FINAL Meeting Notes
Lewis River License Implementation
Aquatic Coordination Committee (ACC) Meeting
September 13, 2007
Ariel, WA

Subject: Response to Washington Department of Fish and Wildlife Comments on the Swift Canal
Upper Flow Release Projects

Figure 1. Merwin Trap capture timing by species (last update 8/28/2007).

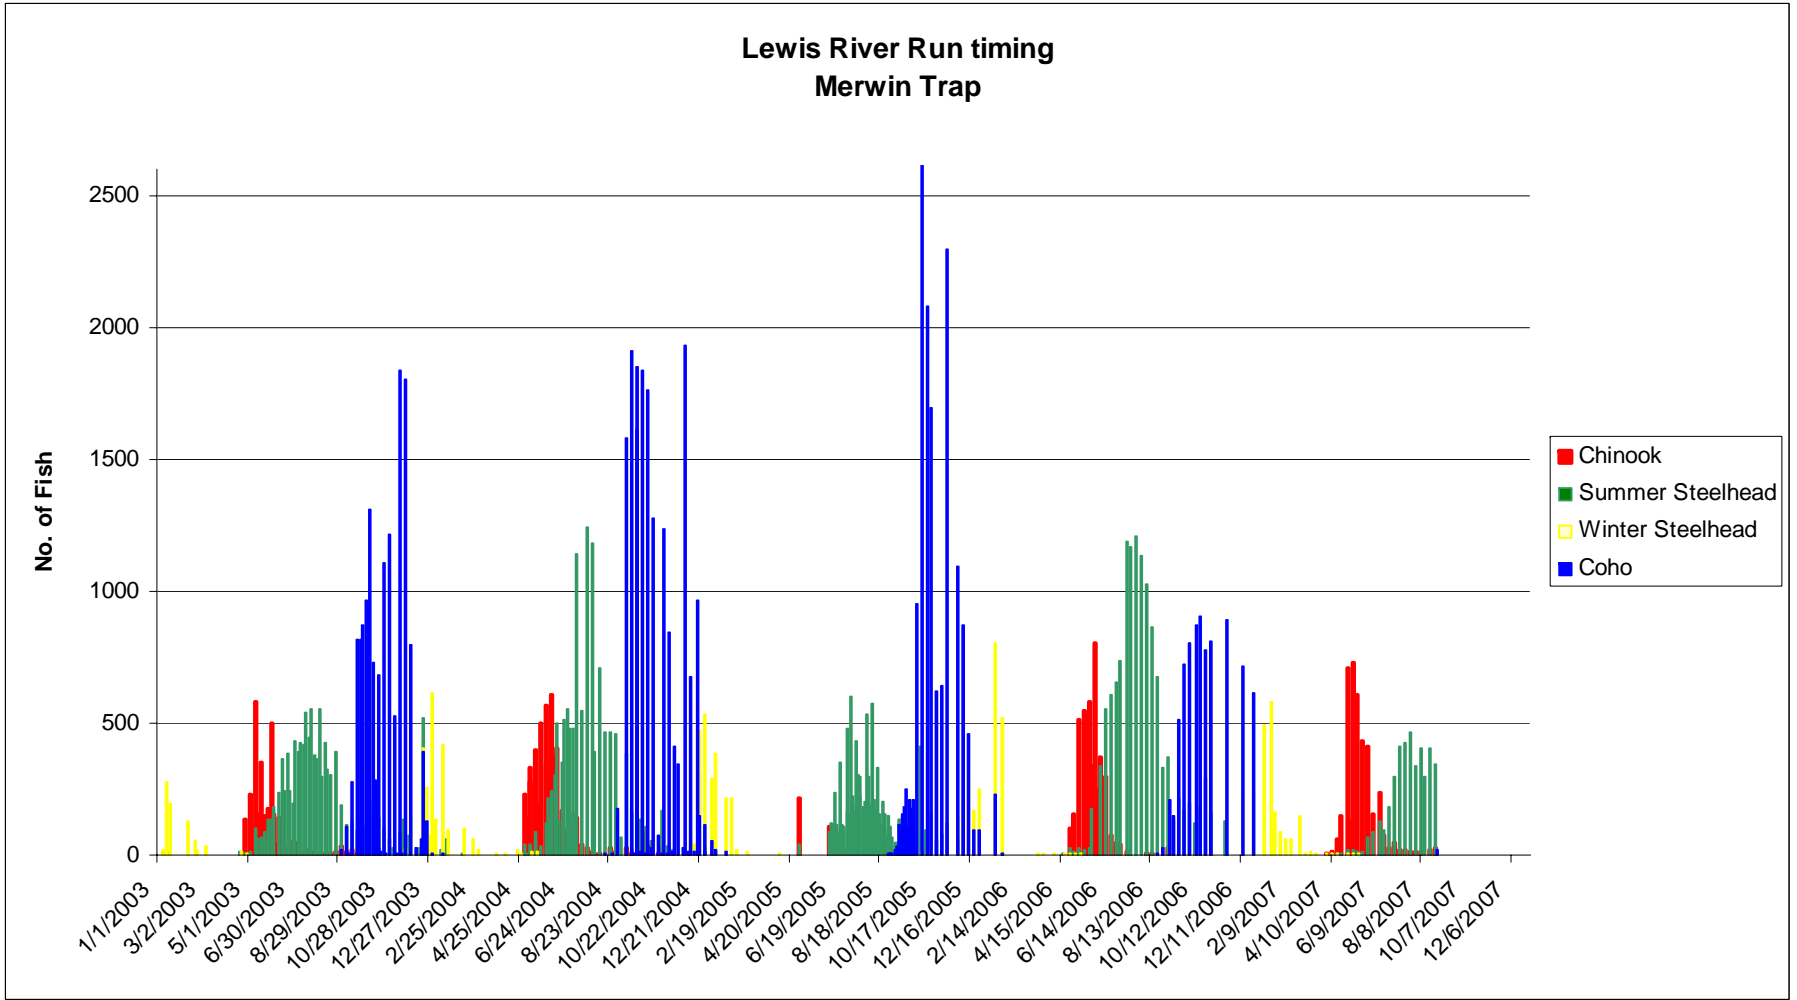
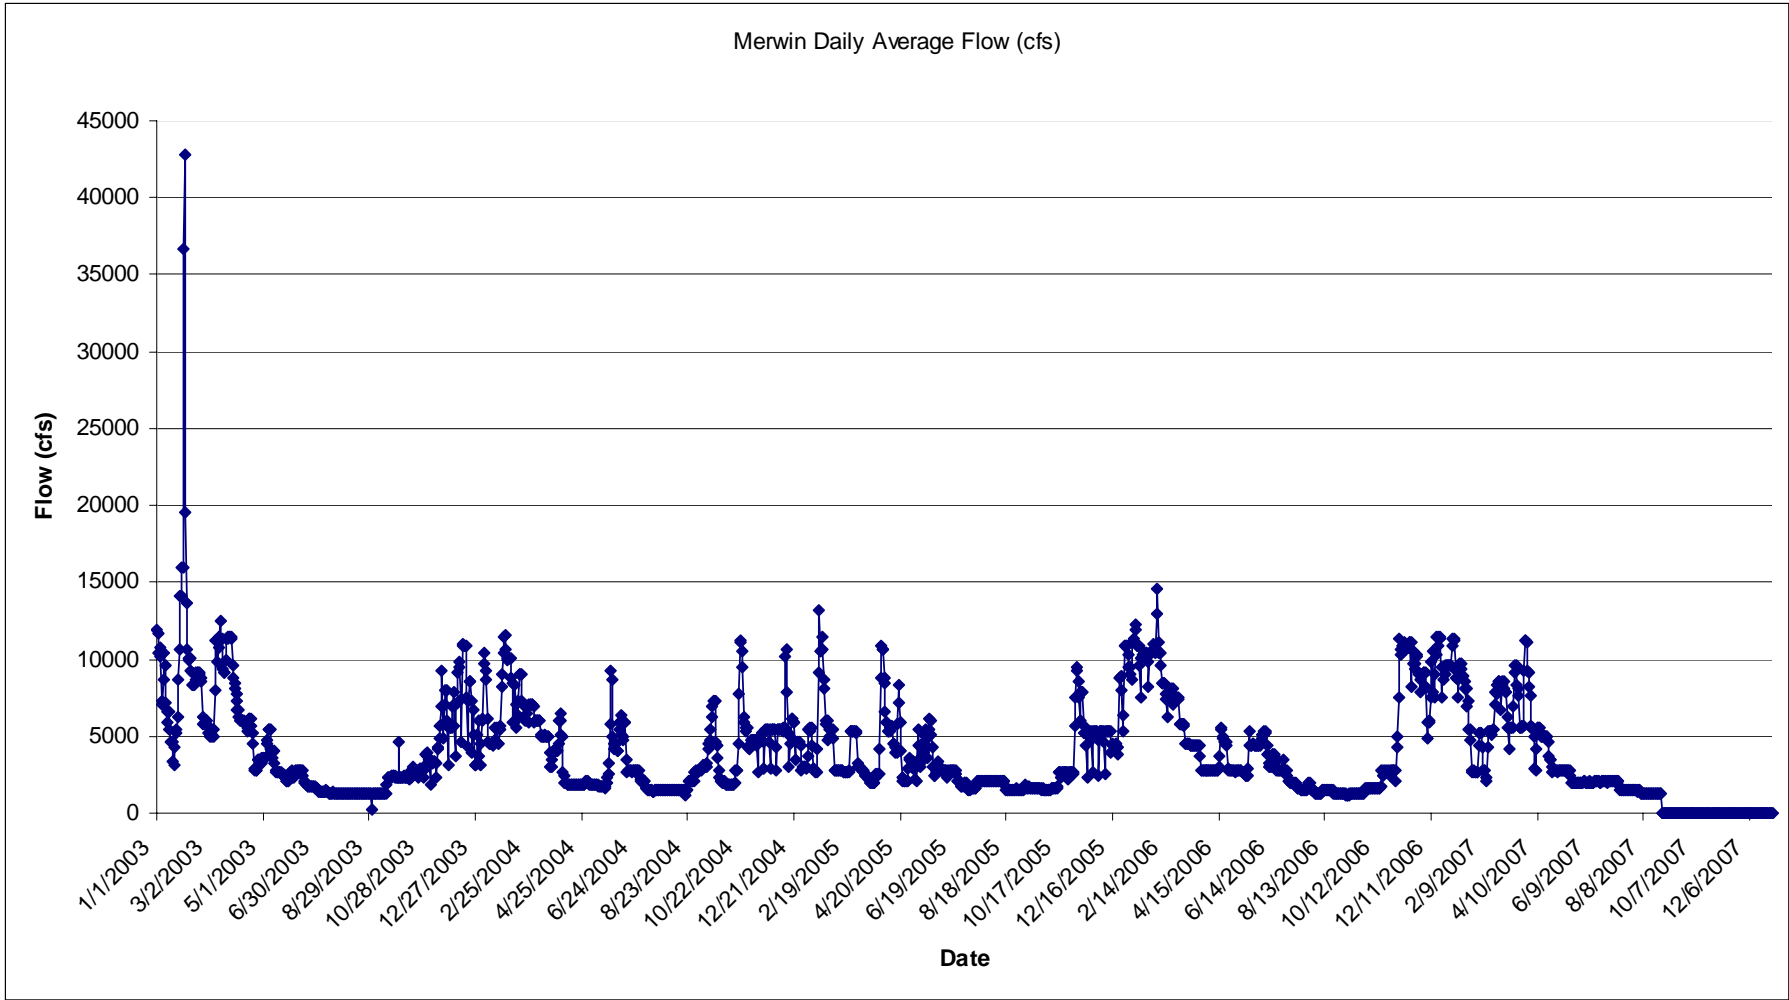
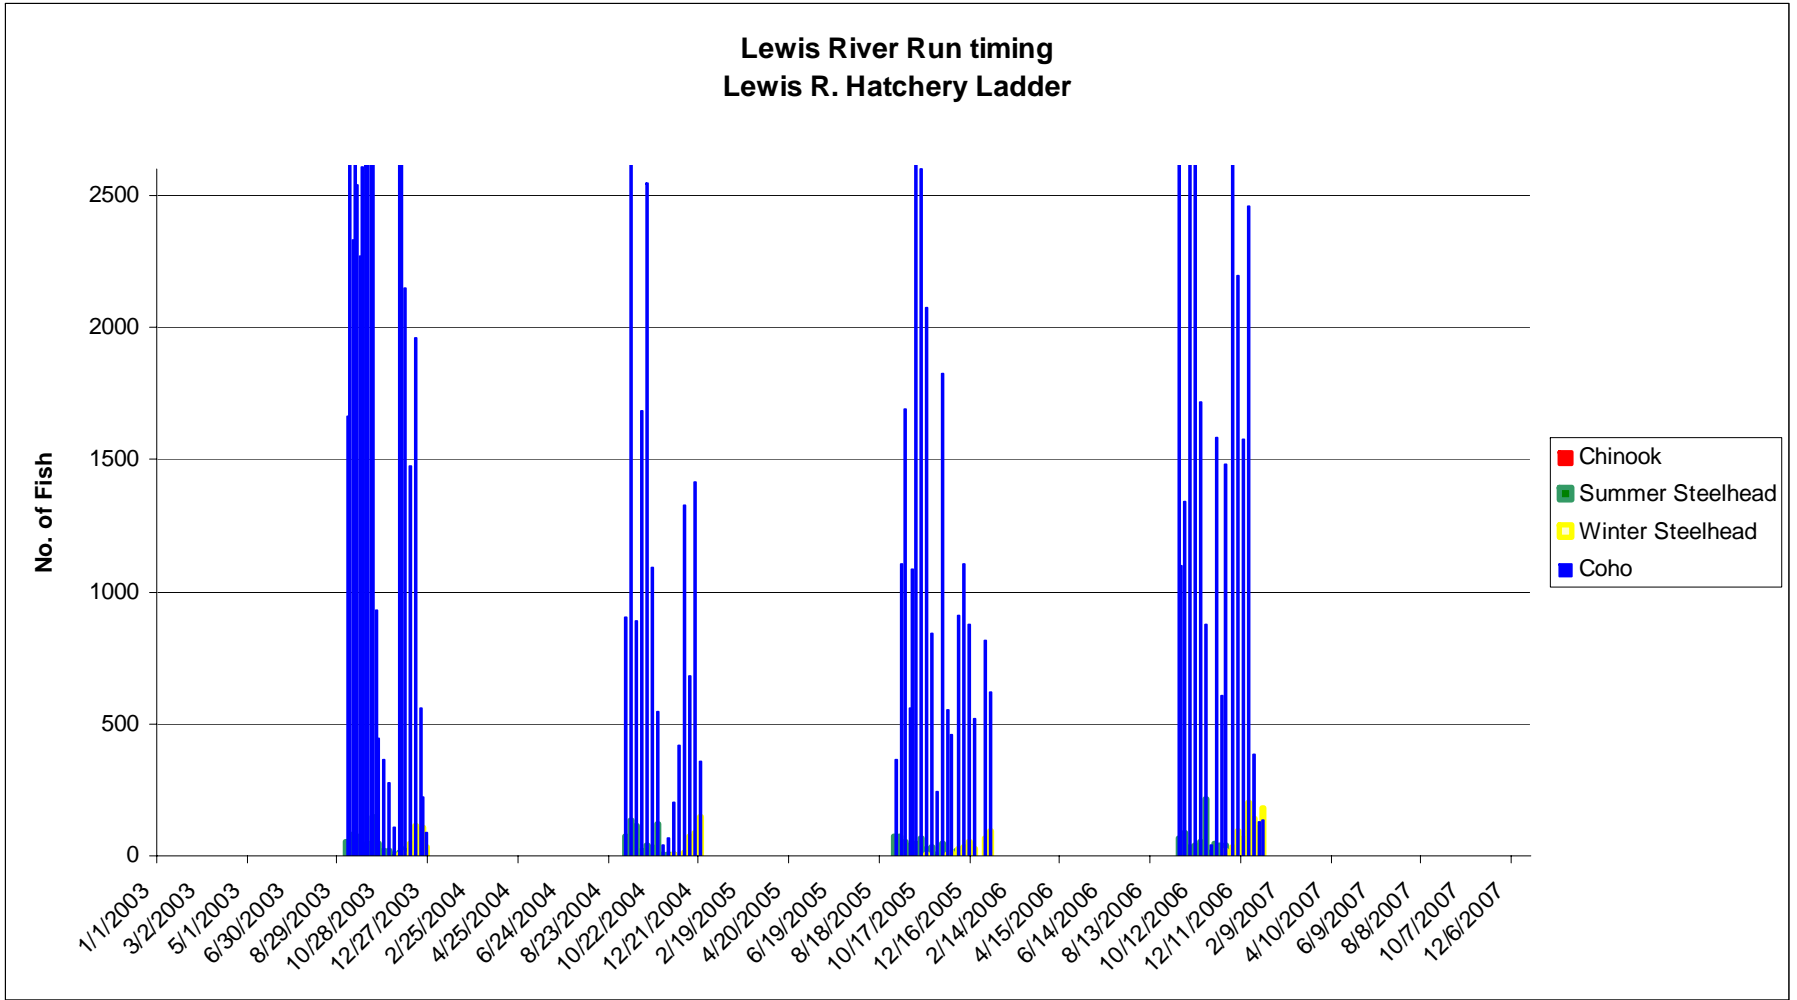
Shrier reminded the ACC attendees that PacifiCorp has identified a six month outage period during construction of the Merwin trap at which time the Lewis River trap will be the backup trapping facility. In order to provide further detail Shrier created a graph illustrating Lewis River run timing at Merwin Trap, Merwin daily average flow and Lewis River run timing at the Lewis River Hatchery Ladder, which was distributed to the ACC and Engineering Subgroup on August 29, 2007 and today in hardcopy, **Attachment B**.

Michelle Day (NMFS) asked which hatchery fish will be in the river during the June – December proposed outage period. Shrier indicated that all hatchery stock will be in the river during the requested time frame.

Pat Frazier (WDFW) expressed that after conferring with other staff members within WDFW they prefer a July to December outage period. Shrier expressed that PacifiCorp may need to extend the outage into January if high water, or other unanticipated delays are experienced during the six month period.

When asked by the ACC, Nordlund indicated that typically a good estimate for the construction sequencing and duration would come at the 90% design level. The ACC participants agreed that WDFW's proposed July 1st to December 31st is an acceptable period for trap closure/outage during construction of the new trap. PacifiCorp will advise the engineering subgroup that we have a general window of closure and to consider reduction of closure whenever possible. However, Bryan Nordlund and Michelle Day wanted the ACC to think about any other alternatives that would help reduce the number of hatchery fish on the spawning grounds.
